DOCKET 11-AAER-2
DATE <u>JAN 02 2012</u>
RECD. <u>JAN 06 2012</u>

NOTICE OF PROPOSED ACTION December 14, 2011

California Energy Commission
Dockets Office, MS-4
Re: Docket No. 11-AAER-2
1516 Ninth Street
Sacramento, CA 95814-5512

Comment of APC by Schneider Electric

Diagram 1
Standby Topology UPS

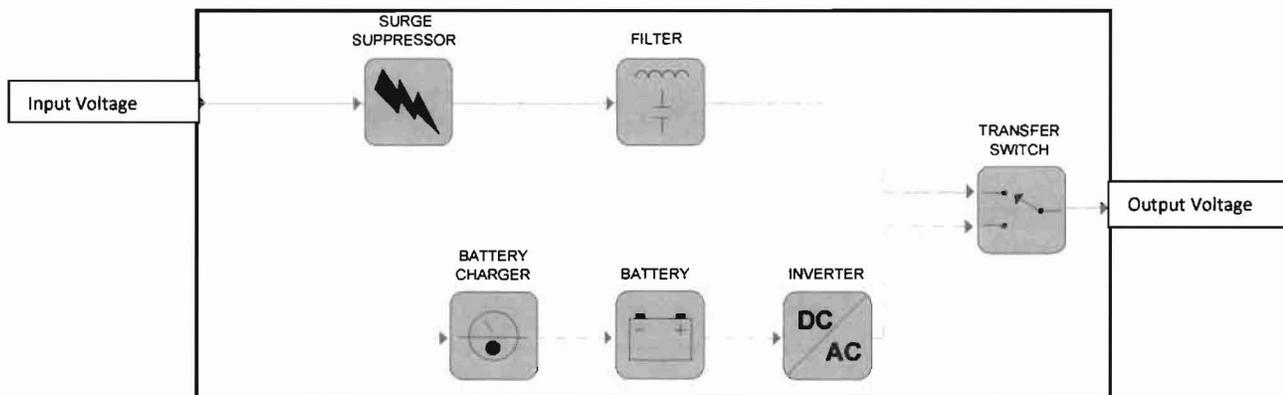
As you can see from the diagram, the battery charger and battery circuitry is not in the direct path of power. However, other component such as filters and surge suppressors are. What this means practically is that measuring the battery charger components outside of the influence or control of other components is an unreasonable burden on the design for UPS systems.
